ALERT SERVICE BULLETIN

429-16-29

MODEL AFFECTED: 429

SUBJECT: FWD CENTER FIREWALL WELDED ASSEMBLY 429-069-501-101/-109/-113 AND AFT CENTER FIREWALL WELDED ASSEMBLY 429-069-504-101/-103/-105/-107, INSPECTION AND REPAIR OF

Figure 2 – Part II - A (Sheet 1 of 5)

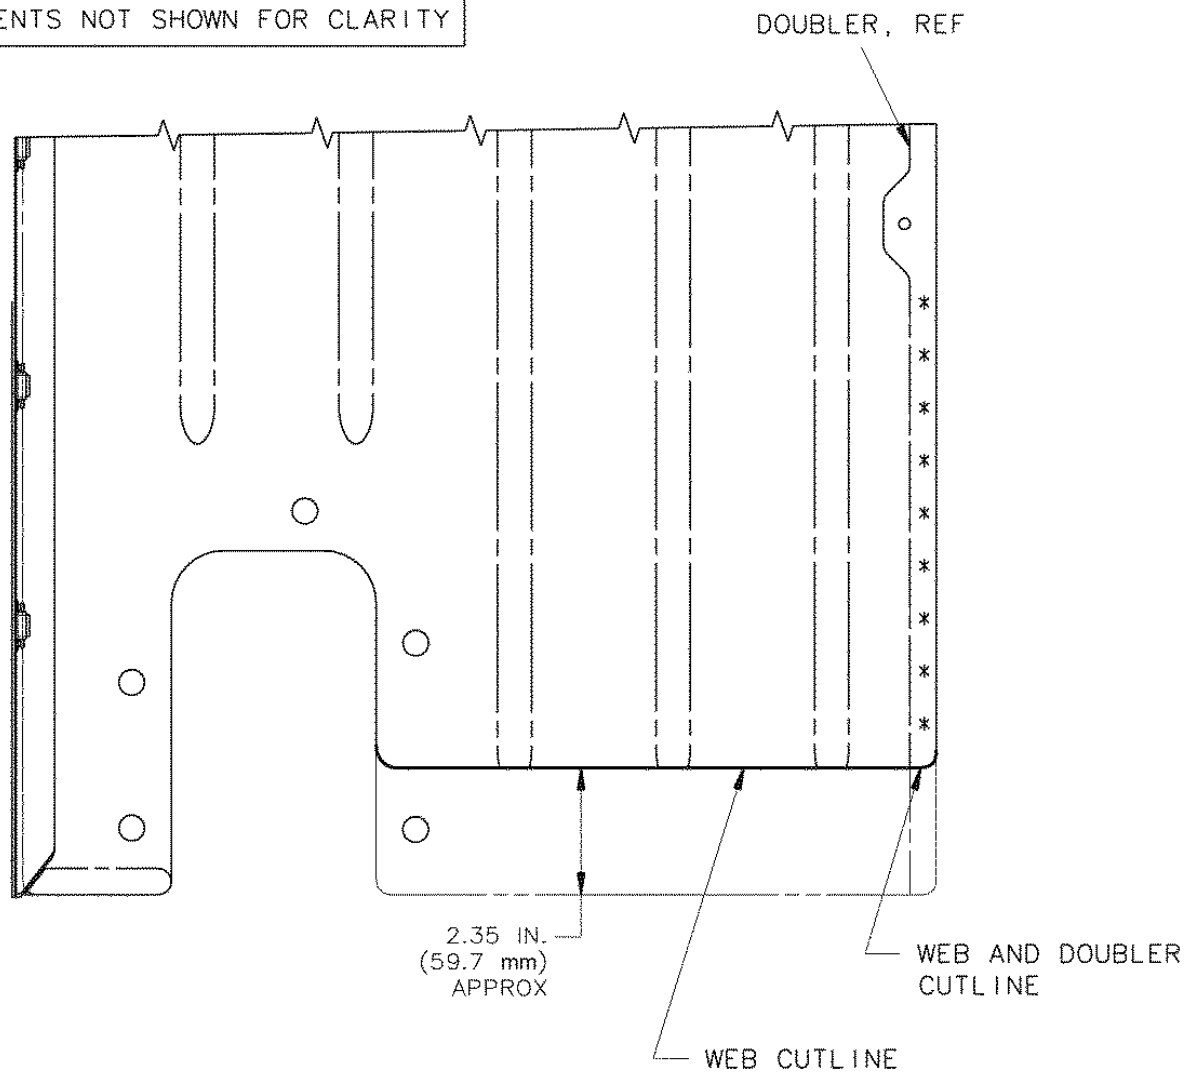
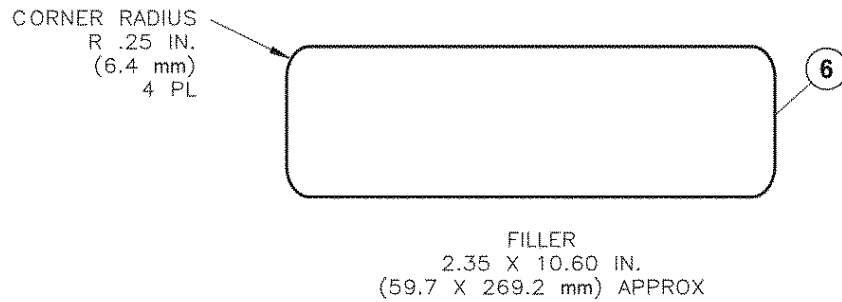
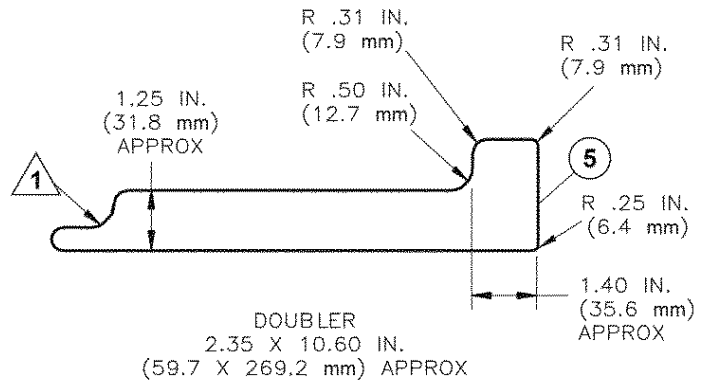
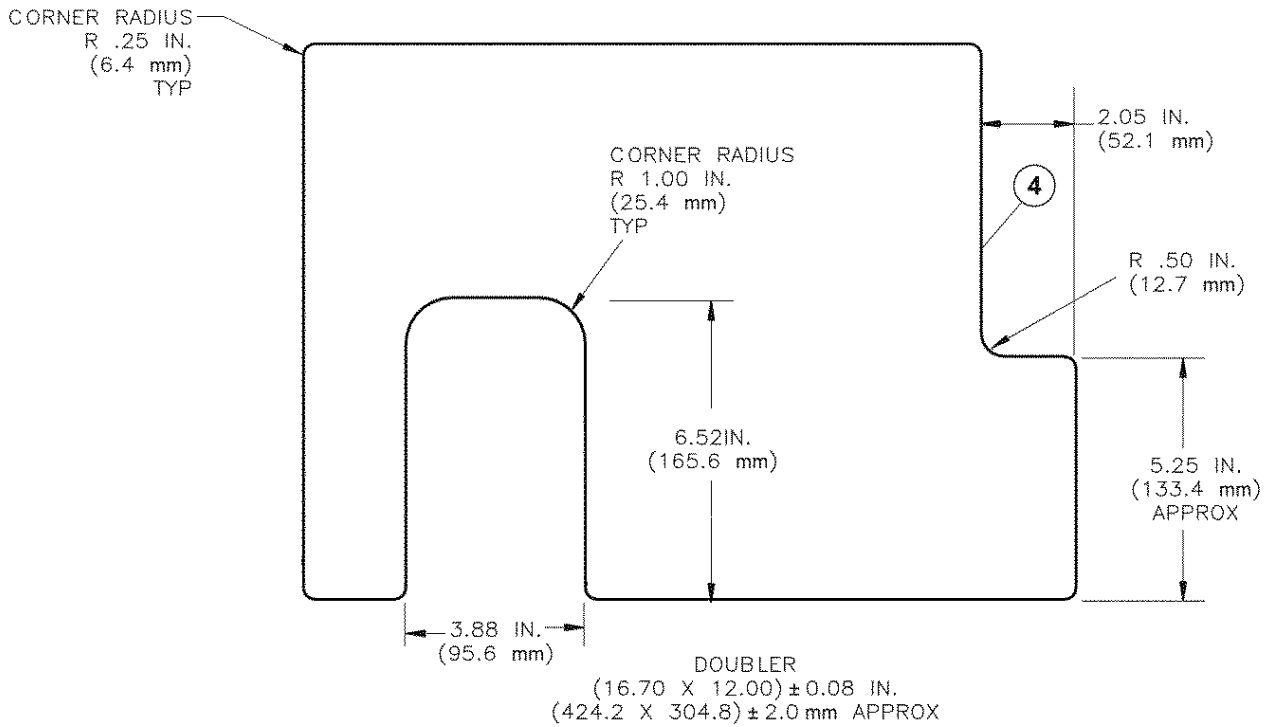
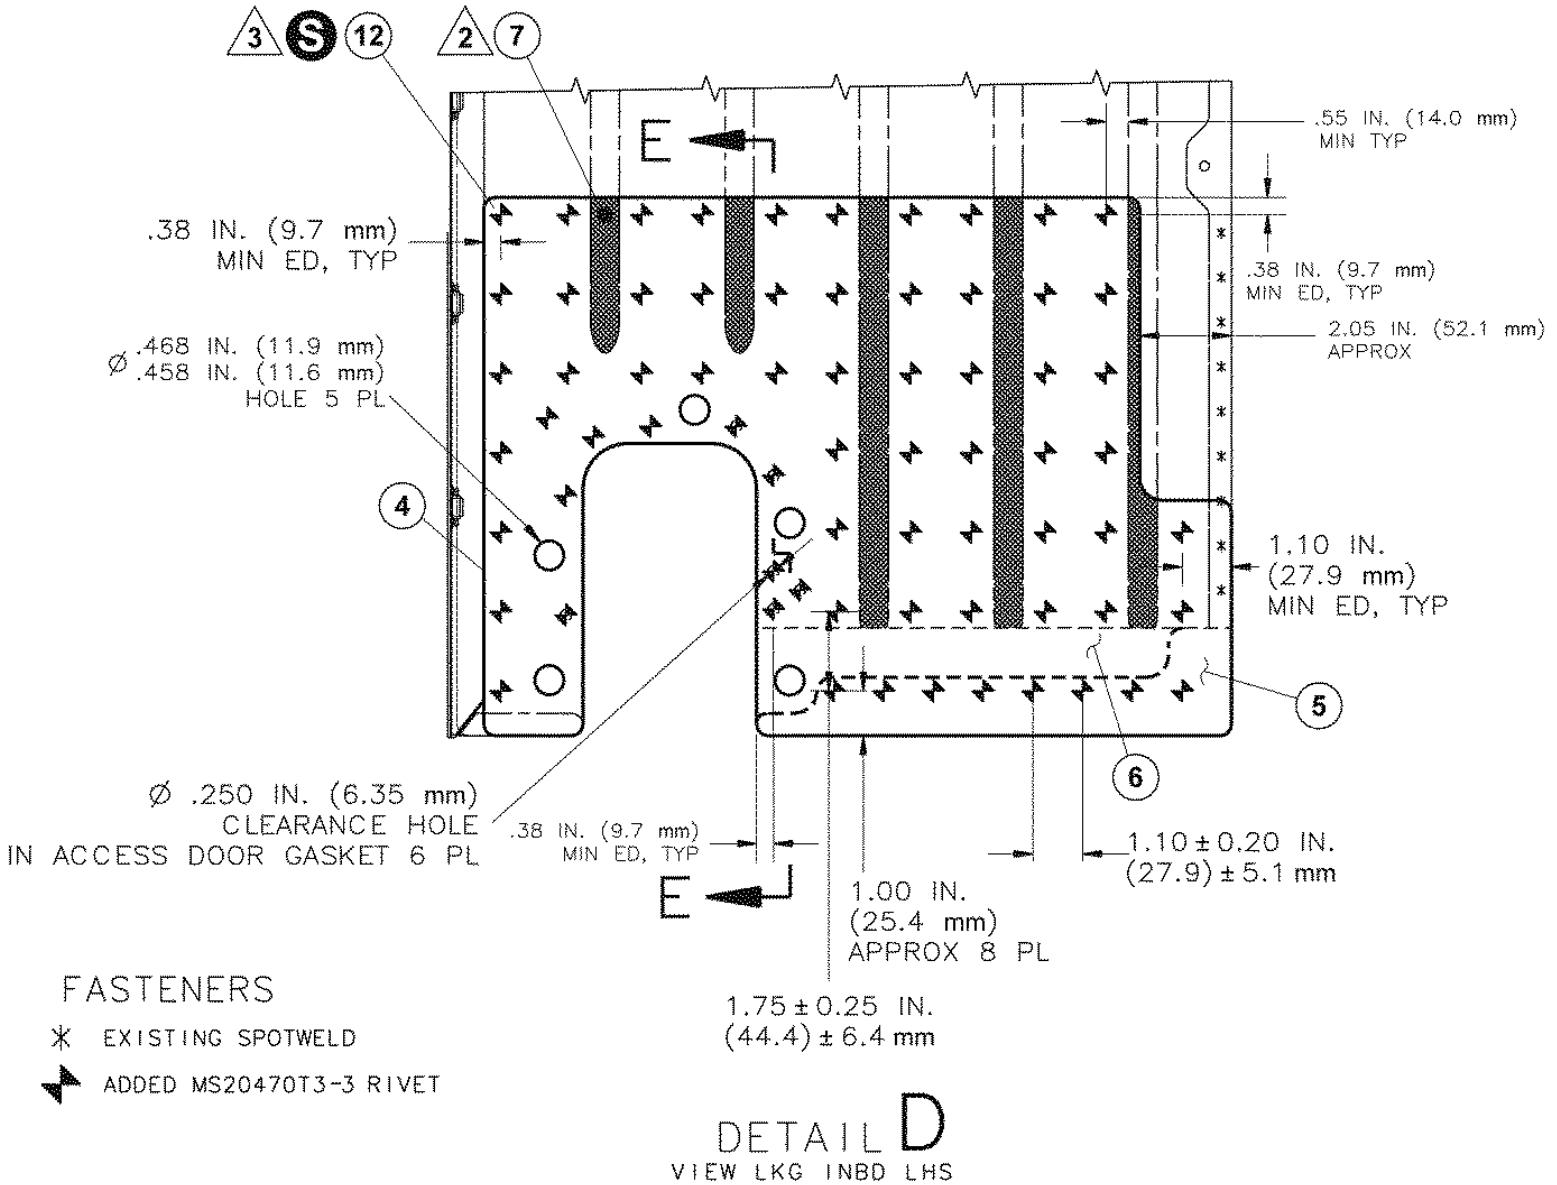
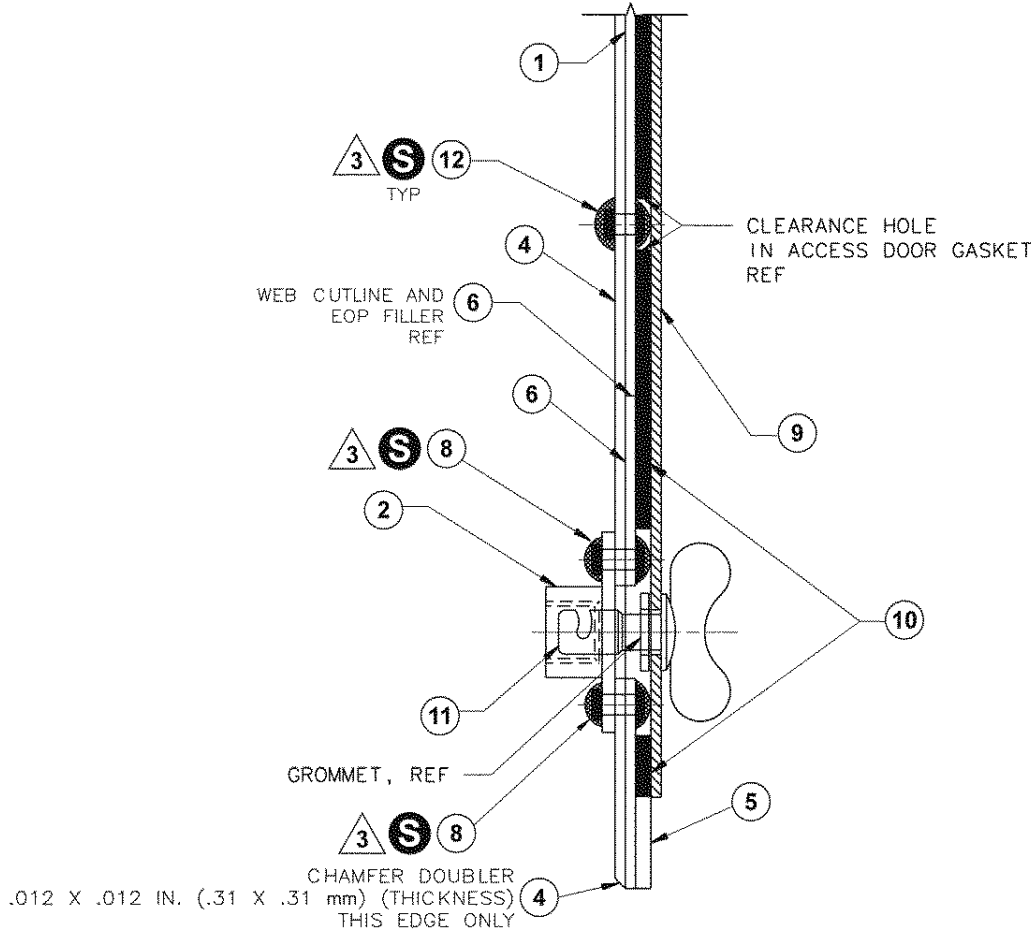
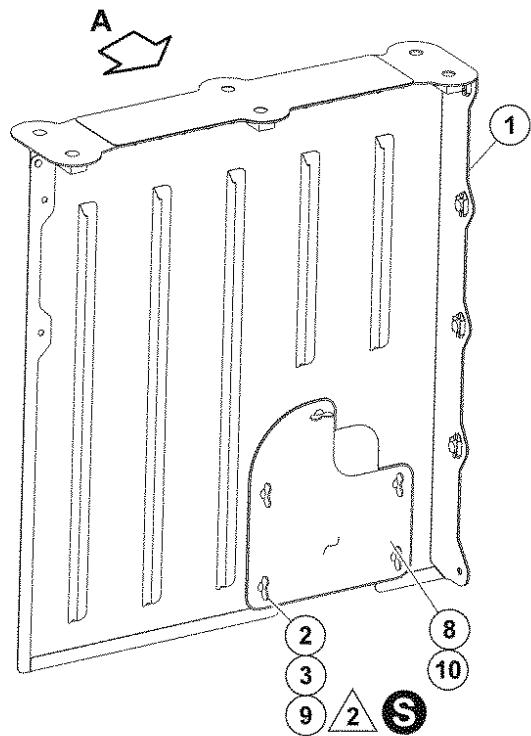
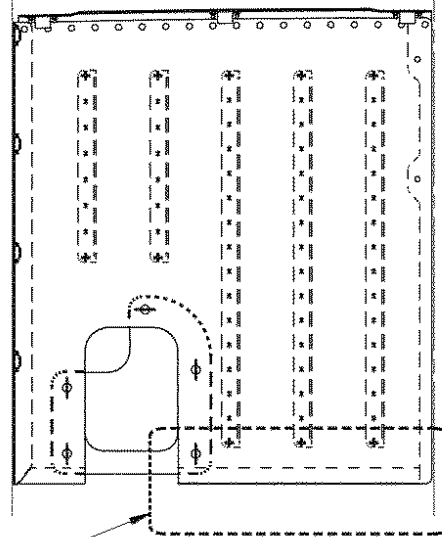
- b. If cracks are detected on the FWD center firewall welded assembly 429-069-501-101/-109, comply with **Part II - A** (Figure 2), if not previously accomplished.
 - (1) If **Part II - A** has previously been accomplished, or a Bell Helicopter approved structural repair has previously been accomplished, remove and replace the cracked FWD center firewall.
- c. If cracks are detected on the FWD center firewall welded assembly 429-069-501-113, comply with **Part II - B** (Figure 3), if not previously accomplished.
 - (1) If **Part II - B** has previously been accomplished, or a Bell Helicopter approved structural repair has previously been accomplished, remove and replace the cracked FWD center firewall.

3. Cut out and remove the damaged portion of the FWD center firewall welded assembly (1) and doublers. Cutout to be as per dimensions shown in Detail B.

4. Inspect the exposed areas of the FWD center firewall welded assembly (1) and the surrounding structure for corrosion, cracks, chafing, or damage. Make sure the spot welds adjacent to the cutline are intact (Detail B). If any such damage exists, submit to PSE with details describing the extent of the damage.

5. Fabricate the doubler (4) using the repair sheet 150-021-31C1-2 and dimensions shown in Detail C.
6. Chamfer the doubler (4), as shown in Section E-E.

7. Fabricate the doubler (5) using the repair sheet 150-021-35C1-1 and dimensions shown in Detail C.
8. Locate the access door panel (9) on the FWD center firewall welded assembly (1).

9. Locate the doubler (5) in position on the FWD center firewall welded assembly (1) and trim to make sure it does not interfere with the access door panel (9) (Detail C, Detail D, and Section E-E).

10. Remove the access door panel (9).
11. Fabricate the filler (6) using the repair sheet 150-021-31C1-2 and dimensions shown in Detail B and Detail C to fit the cutout area in the FWD center firewall welded assembly (1).

12. Locate all of the repair parts (4, 5, and 6) in position and drill to accommodate the new fastener locations (Detail D). Make sure proper edge distance and spacing is achieved. Refer to [Table 3-28 of ALL-SRM](#) for the appropriate fastener hole sizes.

13. Transfer the five 0.458 to 0.468 inch (11.63 to 11.89 mm) diameter holes into the doubler (4) and the filler (6) (Detail D).
14. Locate the access door panel (9) in position and mark the position of the added fastener holes common to the gasket (10) (Detail D, Section E-E). Make sure proper edge distance is achieved.

15. Remove the access door panel (9). Rout a 0.25 inch (6.4 mm) diameter hole on the gasket (10) at the added fastener hole locations (Detail D).

17. Locate and secure all of the repair parts (4, 5, and 6) using fasteners (12), as shown in Detail D.
18. Fill the area between the bead stiffeners (7) and the doubler (4) with firewall sealant (C-353).
19. Locate and secure the receptacles (2) using fasteners (8).
20. Seal all edges of the repair area on the FWD center firewall welded assembly (1) with firewall sealant (C-353). Make sure the edges of the doublers (4 and 5) and the filler (6) are sealed and that the rivet heads and shop heads are overcoated with firewall sealant (Section E-E).
21. Reinstall the repaired FWD center firewall welded assembly (1) on the helicopter ([DMC-429-A-71-30-00-03A-720A-A](#)).
22. Make an entry in the helicopter logbook and historical service records indicating compliance with **Part II – A** of this ASB.
23. Repeat the inspection requirements of **Part I** every 100 flight hours.
